ADDENDUM NO. 1

To Project Bidding Documents for:
TV-23 Bio-Tech Classroom
Compton Community College

tBP Project. No. 21105.00

tBP/ARCHITECTURE

drawing no.:
AS-1
 drawing of

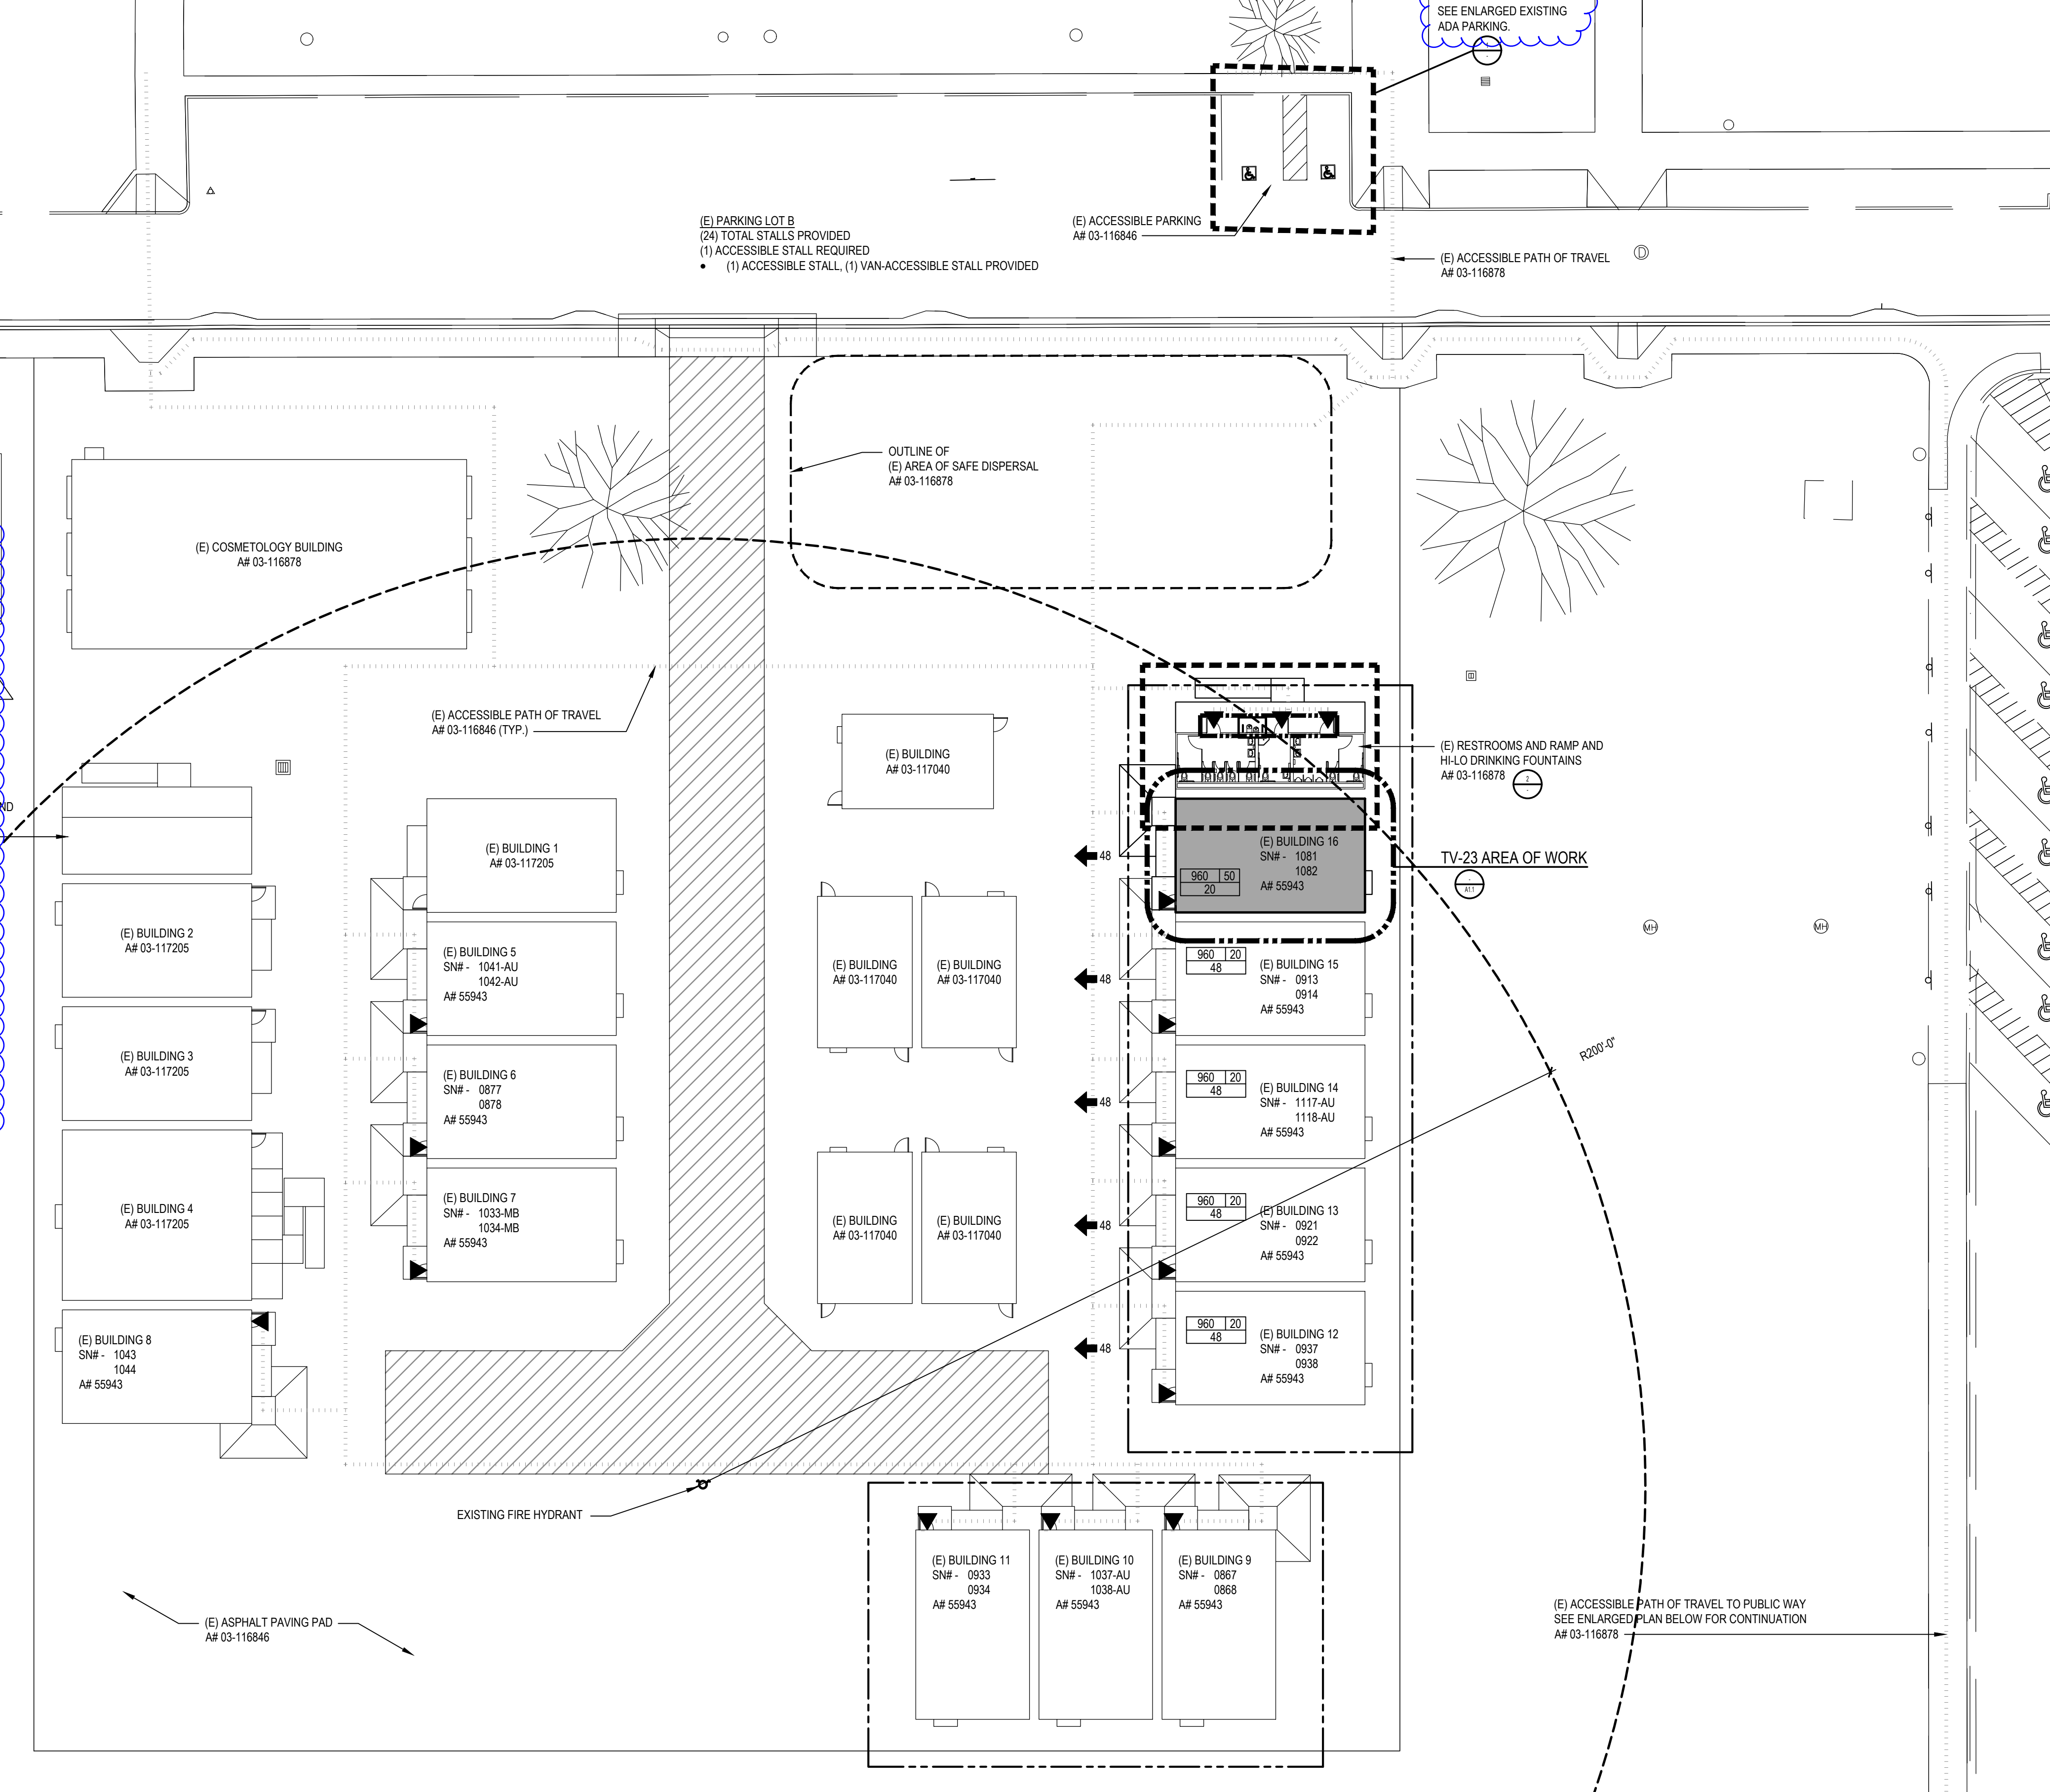
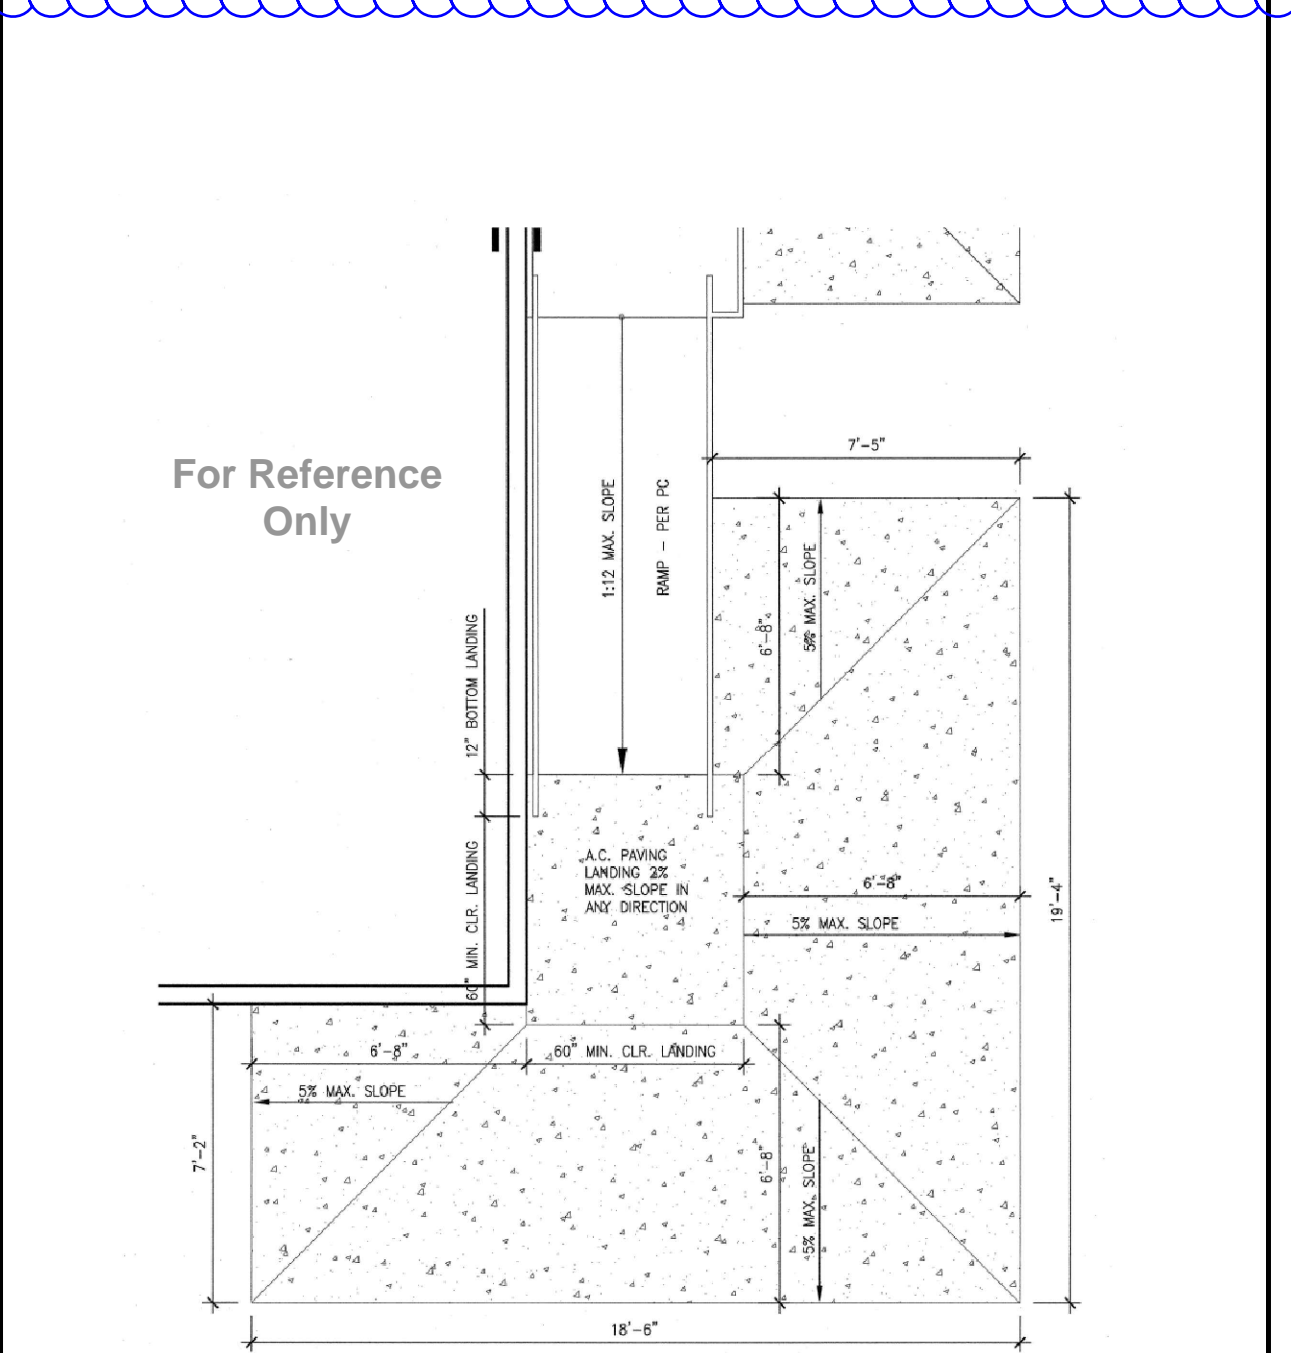
1. SHEET T-2 **SHEET INDEX AND GENERAL INFORMAITON** - Drawing List Architectural sheets replace D-3 by A-3
2. SHEET AS-1-- **ENLARGED SITE PLAN** Added detail for parking sign, added notes clarifying scope at ADA parking Relocation of drinking fountain is shown. **See attached revised sheet.**
3. SHEET A1-1 **FLOOR/CEILING & INTERIOR ELEVATIONS** Corrected Construction Notes Added clear wire mold location, clarifying notes, 75% demo of the wall paneling drywall. IDF location. **See attached revised sheet.**
4. SHEET A-3 DETAILS. Removed one detail added and updated Drinking fountain relocation and details. **See attached revised sheet.**
5. SHEET P1-1 PLUMBING FLOOR AND SITE PLAN Relocation of drinking fountain was
